SPECIFICATIONS AND DRAWINGS
HOUSING AUTHORITY OF THE CITY OF LUMBERTON: TURNER TERRACE
REPAIR OF FLOOD-DAMAGED UNITS
TWC # 3313-B 03

SUBJECT: ADDENDUM NO. 2

MAY 9, 2019

To the Plans and Specifications for:
Housing Authority of the City of Lumberton: Turner Terrace
Repair of Flood-Damaged Units

2 TYPICAL SINGLE UNIT SERVICE DETAIL
E201 NO SCALE

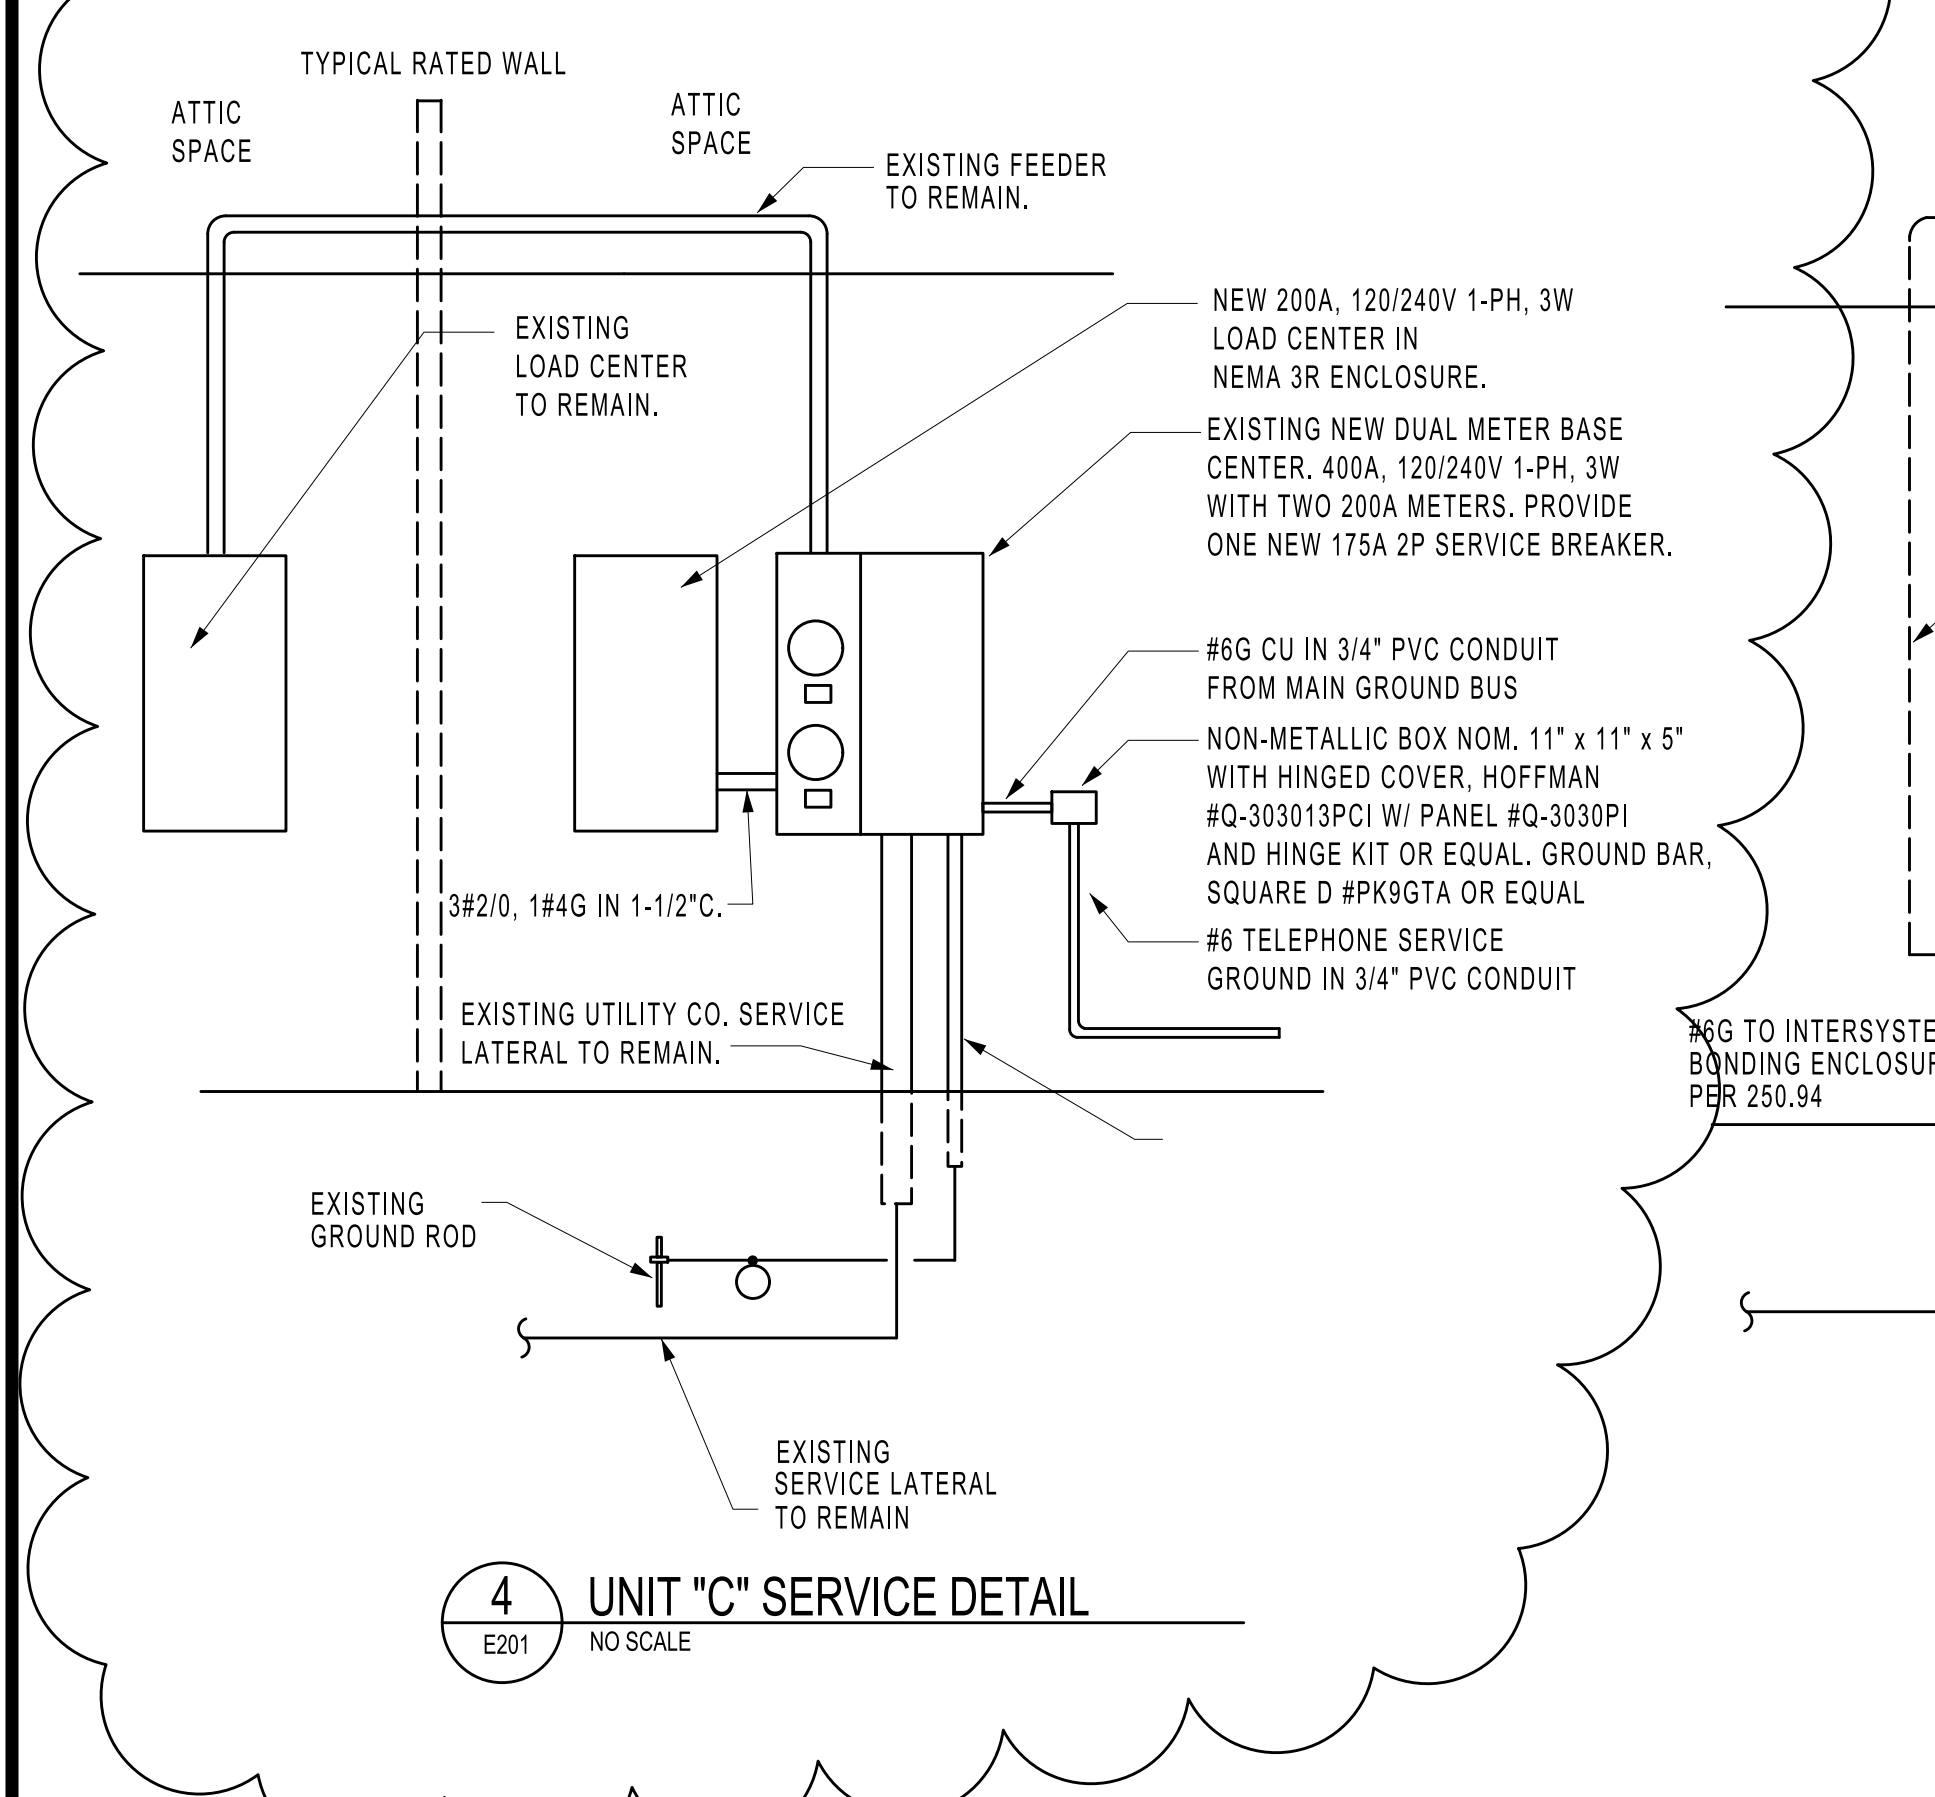
- c. Add circuits for electrical water heaters.
 - d. 2/E201: Revise note for service entrance equipment.
 - e. Add riser 3/E201.
 - f. Add riser 4/E201.
